PROPOSED BUILDING

Construct a Six-Storyed Mixed-Use building, located at the corner of East Madison Street and 15th Avenue. Commercial uses at the Ground Floor, with Residential and Garage entries; Floors 2-6 will be Residential. There will be 2-1/2 levels of below grade parking.

I0 EDG COMMENTS & RESPONSES

OPTION 1 (PREFERRED)

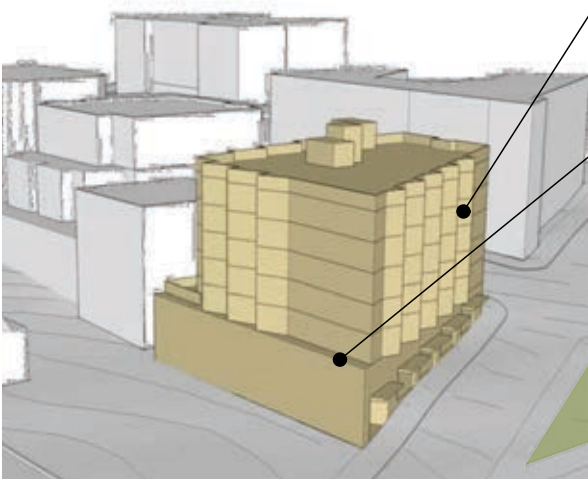
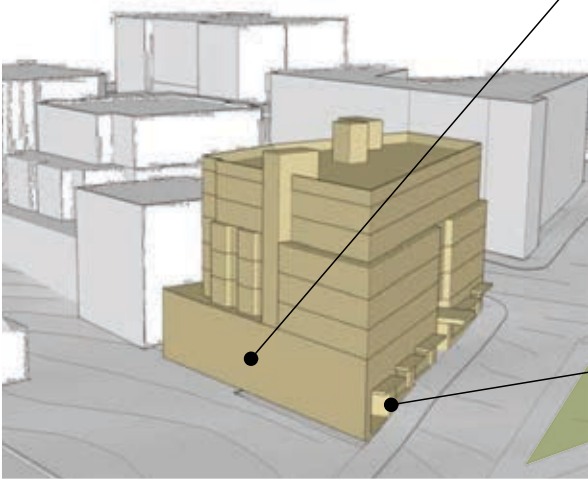
Comment: Strong architectural response at 15th Ave. corner

Comment: "Busy bay windows" in Option 1 and 2 lack context

Comment: Massing to respond to nearby context and site

Comment: Large area of blank facade on west wall

Comment: Quality materials should relate to context

Comment: E. Madison is the appropriate location for residential and garage entrances

Response: Massing strengthened on East facade by removal of bays; Cafe terrace provided at commercial entrance in required City Light setback

Response: Fewer and simpler bay windows, bays eliminated from East facade (See Sheet 13 regarding context)

Response: Increased setbacks on north and west respond to adjacent properties in lieu of upper level setbacks (See Sheet 13 regarding context)

Response: Substantial redesign to increase glazing and accommodate future adjacent development:

- Increased setbacks allow substantial glazing
- Live/Work units and terrace replace 2nd floor parking
- Landscape screening at reduced blank wall

Response: Materials selected to be in harmony with adjacent contemporary structures

Response: All primary entrances on E. Madison

- Garage entrance at SW corner
- Residential entrance mid-block

Nearby Context: Bay Windows

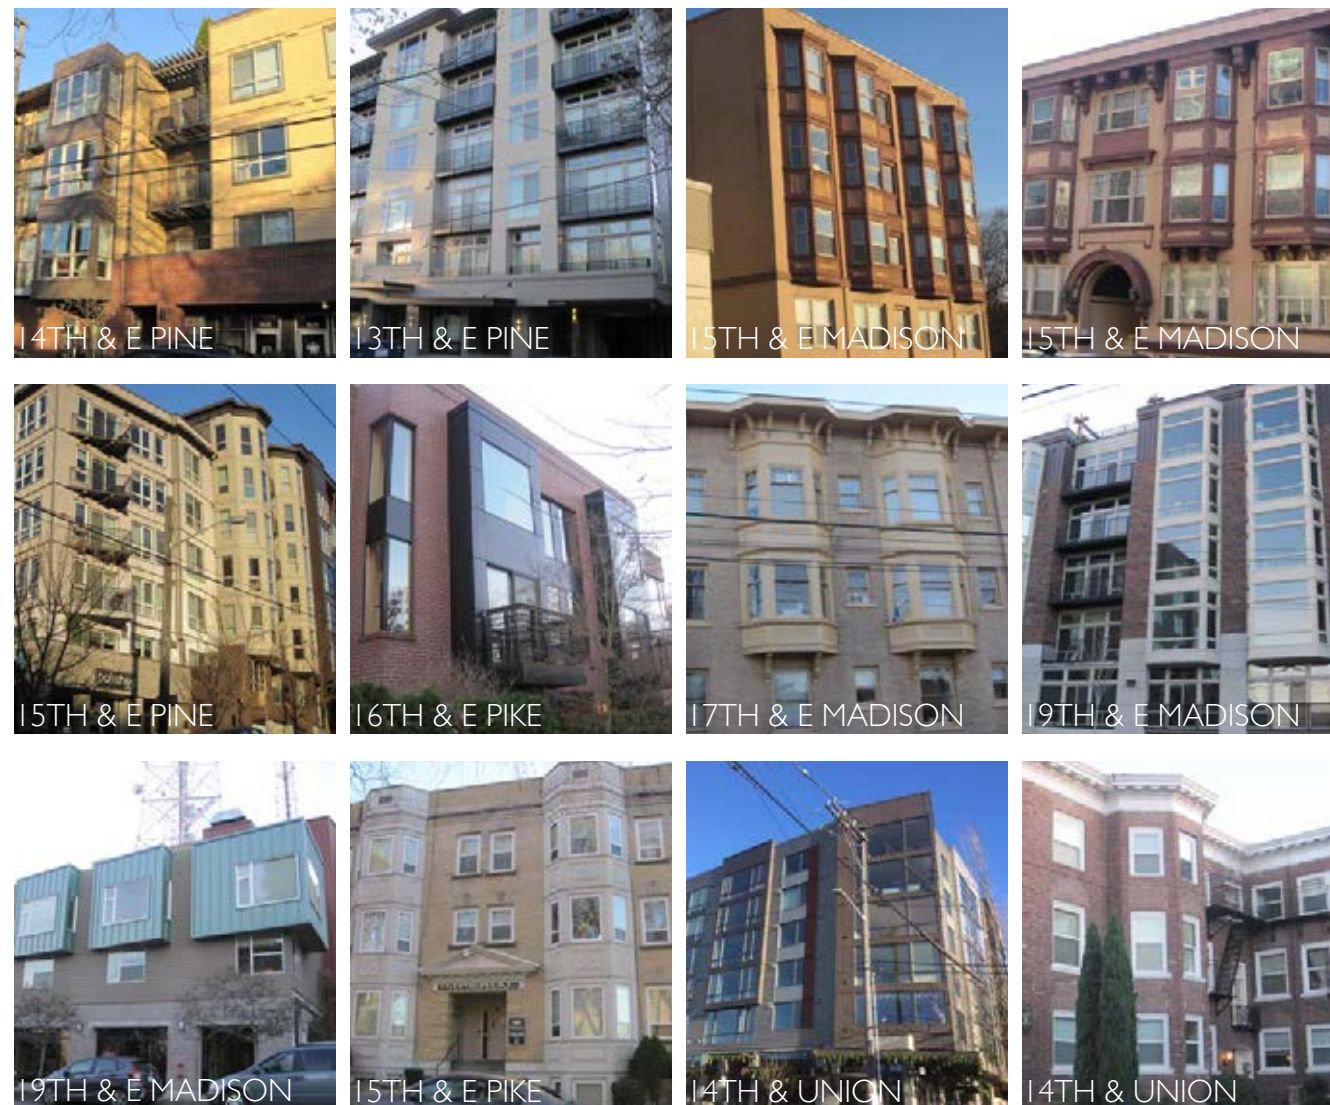
I.a: Provide a design with strongly expressed forms that responds to nearby context.
The board noted that Options 1 & 2 incorporate “busy bay windows” that lack a relationship to recent nearby development.
(CS2-III, CS3-A, CS3-I, CS3-IV)

The Design Review Board's guidance that EDG Options 1 and 2 incorporated "busy bay windows" led us to eliminate the bays from the east façade and reduce the number of bays on the south façade from five to four. We also looked carefully at the local context and found that rhythmic bay windows are a common feature in the nearby neighborhood.

Our survey of the 9-block immediate neighborhood and in the adjacent 10 blocks along E. Madison Street centered on the site found many contemporary and most traditional structures provide regular bay windows of angled or squared design, 12 examples are shown here:

Nearby Context: Upper Level Setbacks

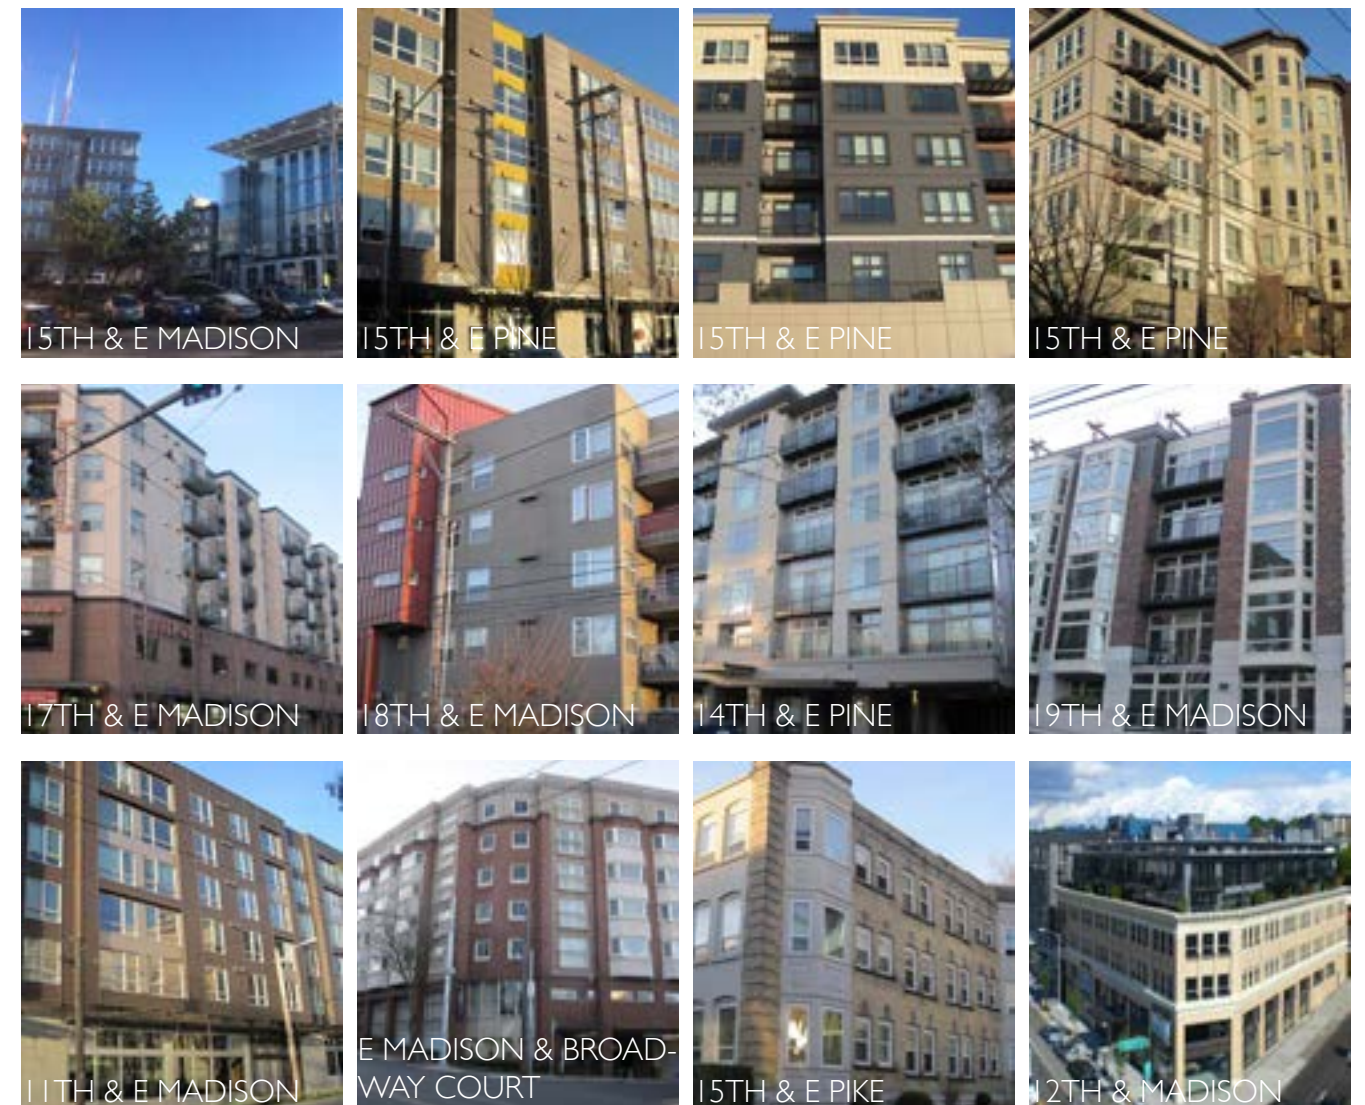
I.b: Board observed aspects of Option 3 that responded well to the context and site: upper floor setback, potential for strong corner response, change in planes (future development)
(CS2-C, CS2-I, CS2-II, CS2-III, CS3-I, DC2-B, DC2-D, DC2-I)

The Design Review Board's guidance to consider alternative massing consistent with the local context "such as upper-level setbacks" led us to analyze more closely the neighboring structures. Our survey of the 9-block immediate neighborhood and in the adjacent 10 blocks along E. Madison Street centered on the site found only one contemporary and no traditional structure with upper-level setbacks. The lone exception is Trace Lofts, a unique condition.

With this context in mind, the proposed design does not provide upper-level setbacks. However, in order to accommodate both existing and future adjacent developments, we have allocated the floor area that might have been applied to upper setbacks to increased side-yard setbacks on the west and north property lines. 12 examples are shown here:

38 GARAGE ACCESS DEPARTURE REQUEST SUPPLEMENTAL STATEMENT I

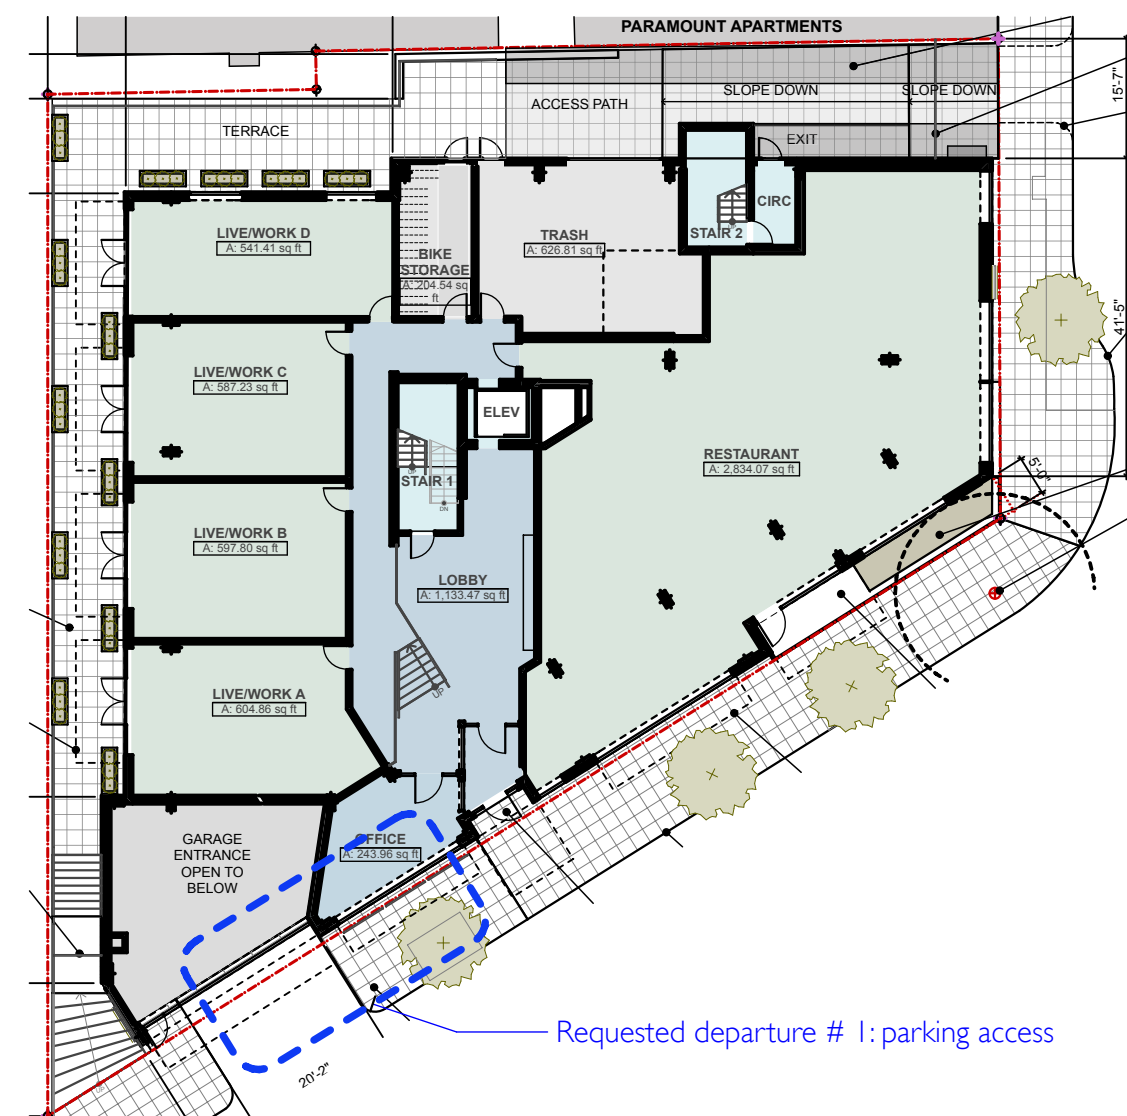
At the third EDG meeting the Board agreed that “the below grade parking should be accessed from E. Madison St near the southwest corner, as proposed.” (See page 11, section 3 of the Third Early Design Guidance). The Board also stated that the easement between the new structure and the Paramount Apartments should be paved and landscaped in a pedestrian-friendly manner, and the requested departure will allow this to happen.

The E. Madison Street driveway access better meets the intent of CS2-D-2 by taking advantage of the change in topography of the site and its unusual shape to minimize the height of the blank wall adjoining the parking garage that faces the property to the west and is visible to passersby on E. Madison Street. Access from E. Madison Street also allows for four additional residential apartments facing west, enhancing the residential character of the building as viewed from the west. It also will allow a better fit with the Paramount Apartments to the north by minimizing vehicle use of the easement by eliminating a 7 car parking garage and limiting use to utility service only, and by allowing it to be paved and landscaped in a pedestrian-friendly manner.

The E. Madison Street driveway access better meets the intent of CS2-D-5 by allowing a building design that better respects both the church property to the west and the apartments to the north, and by minimizing disruptions to the privacy of the residents in the Paramount Apartments from traffic off of 15th Avenue.

The E. Madison Street driveway access better meets the intent of DCI-III-i and ii by minimizing exposed blank walls on the west and north facades. The western façade of the proposed design has one level of above grade parking with a landscaped terrace and four live/work apartments above, and the landscaped terrace will provide an opportunity for vertical landscaping.
